# Bid Addendum 01

Project: UNC Charlotte Science Building:  
Early Package 1  
Existing Building Heating Conversions

Date: November 20, 2017

Prepared by: Mike Romot, AIA, LEED BD+C

**C-050**

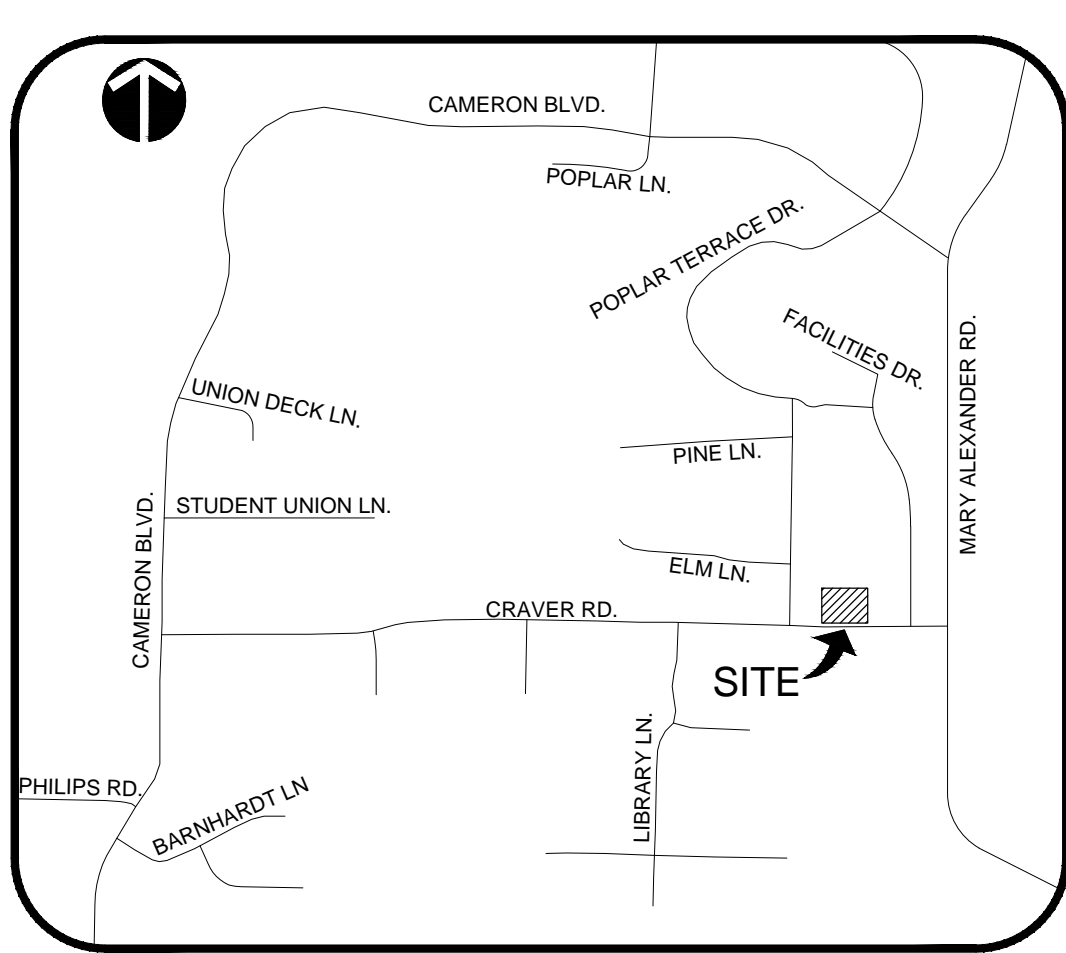
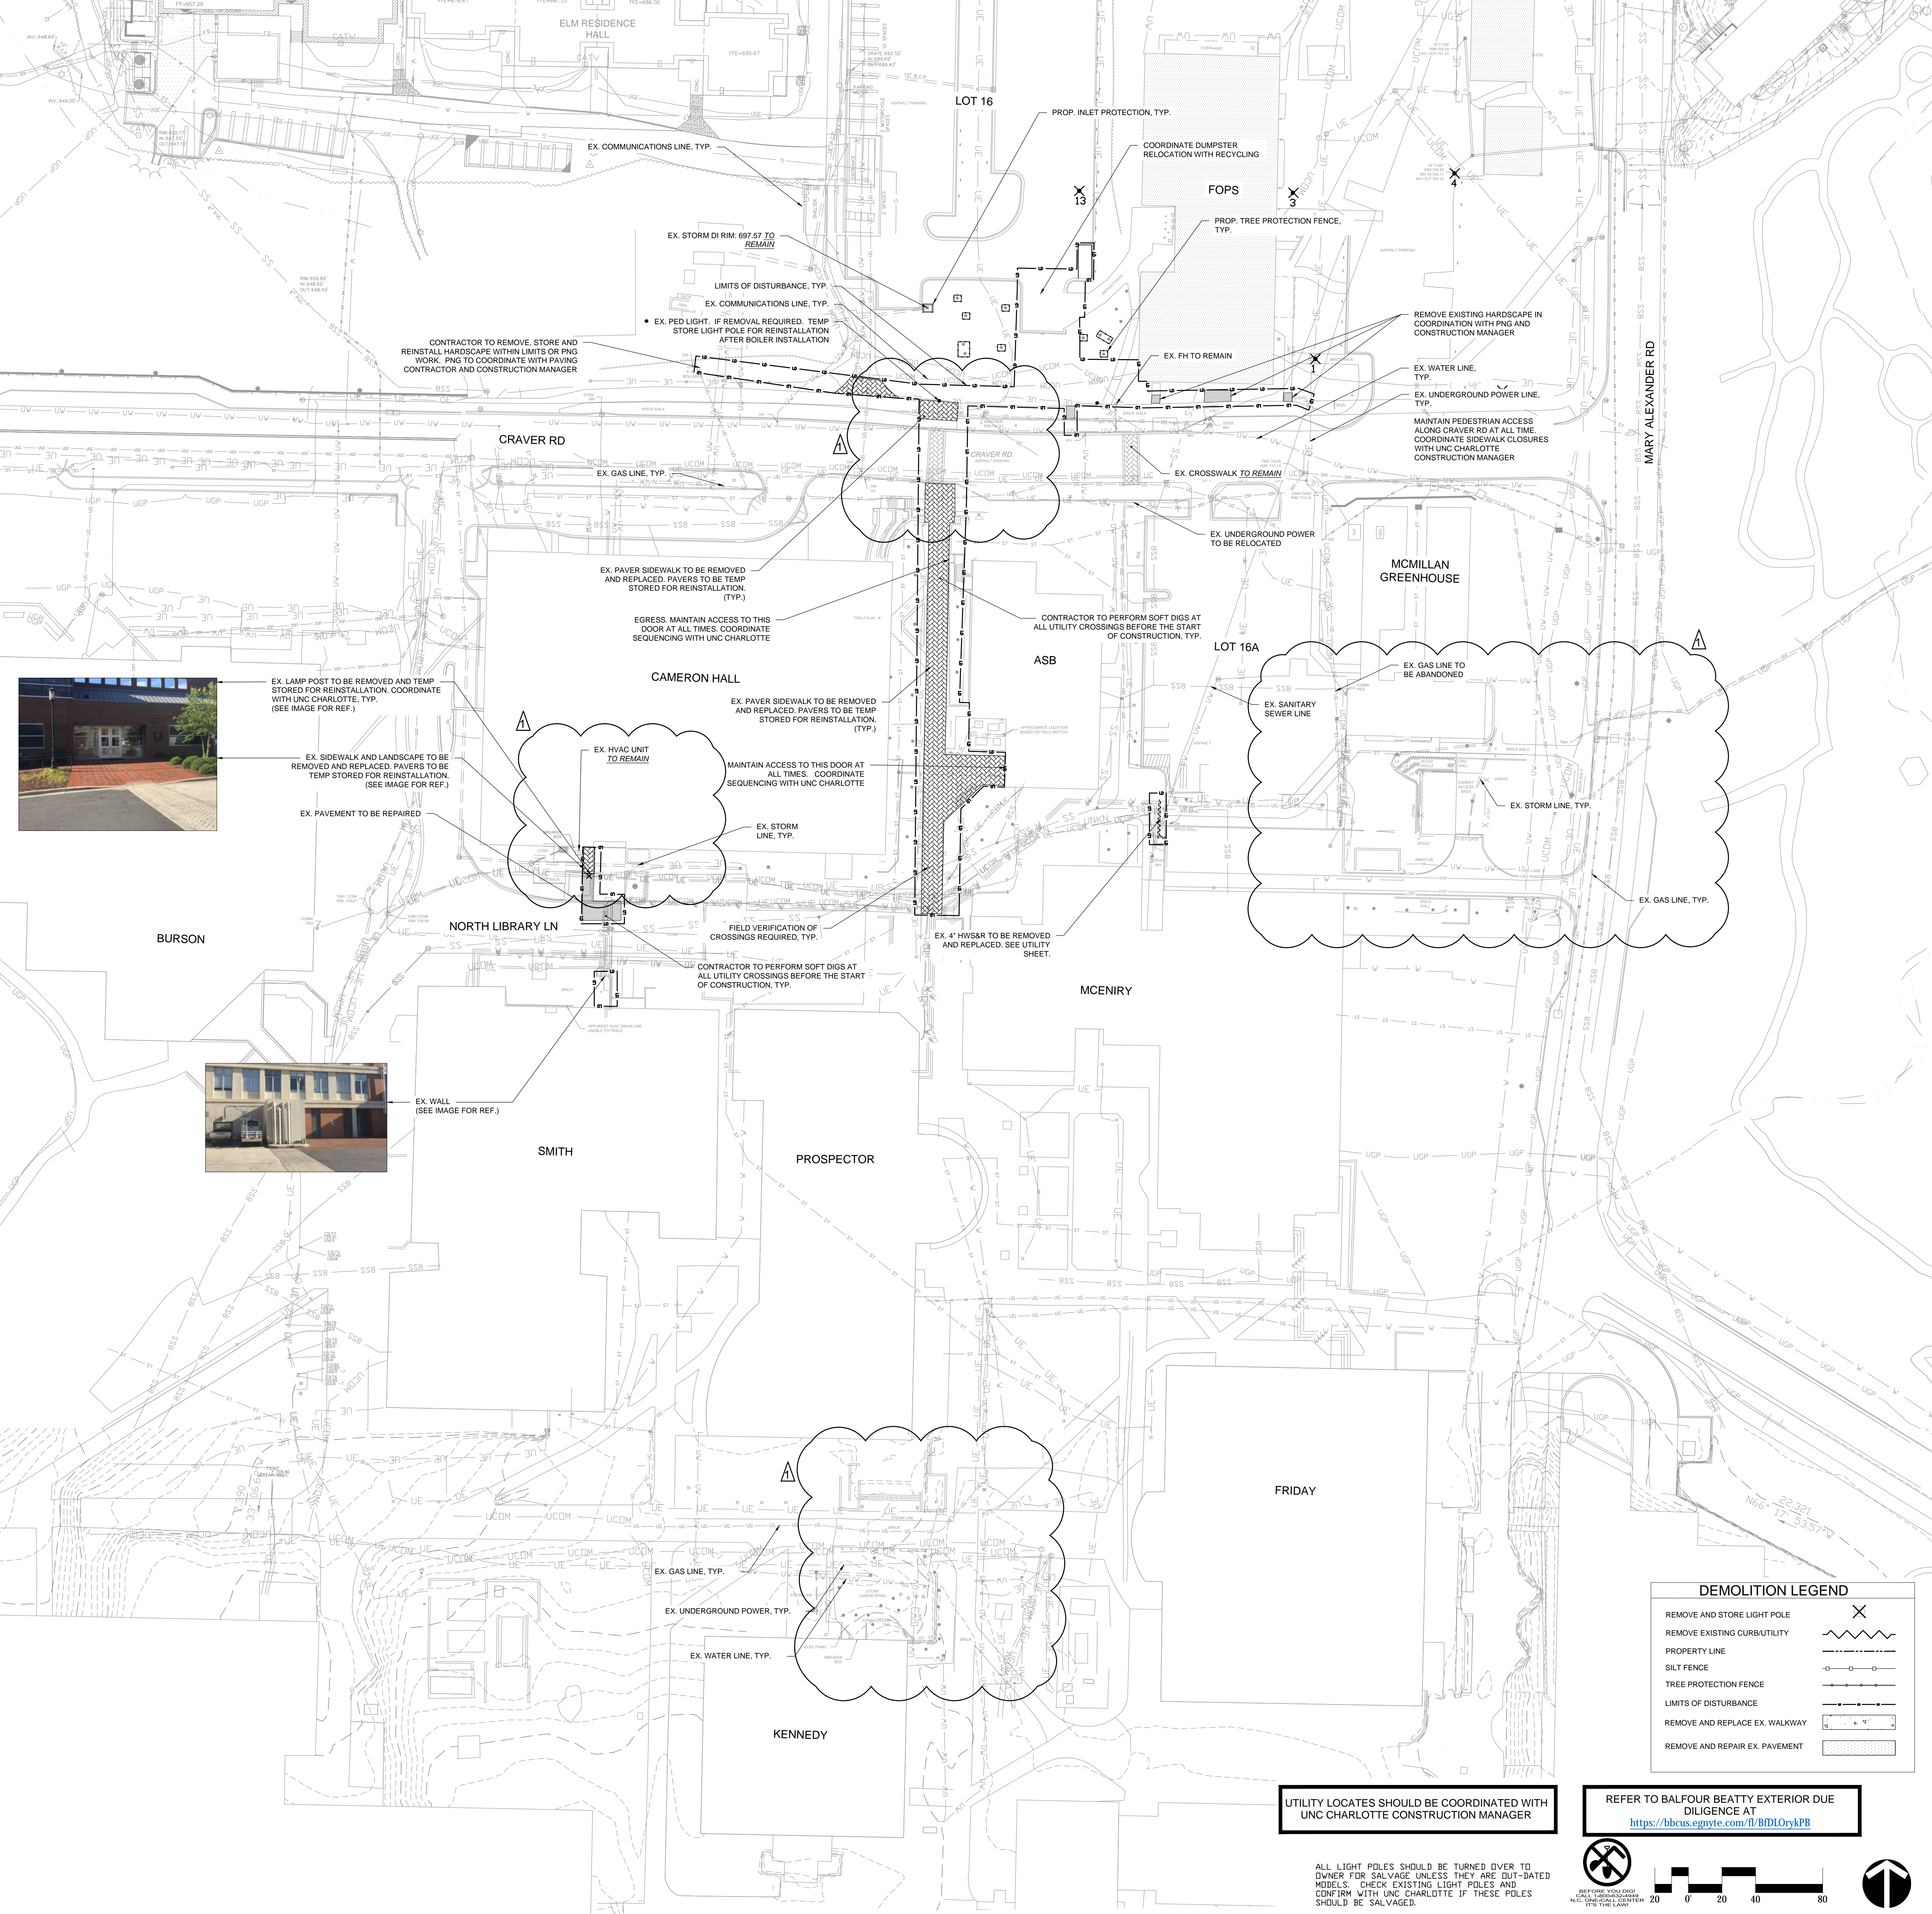
5. **A/C Unit (Drawing Sheet C-050):** Picture shows an outdoor A/C unit at location of new underground hot water piping to be installed. There is no mention of relocating this A/C unit. During the walk-thru there was mention of relocating the underground hot water piping. Provide information of what will be needed. Relocate A/C unit or relocate underground piping so subcontractors can estimate accordingly.

Response: The underground piping enters Cameron in a storage room. There should be sufficient linear wall space to locate the pipes and not disturb the existing AC unit. The exact location of where the pipes shall enter the building will need to be coordinated during the construction phase of the project.
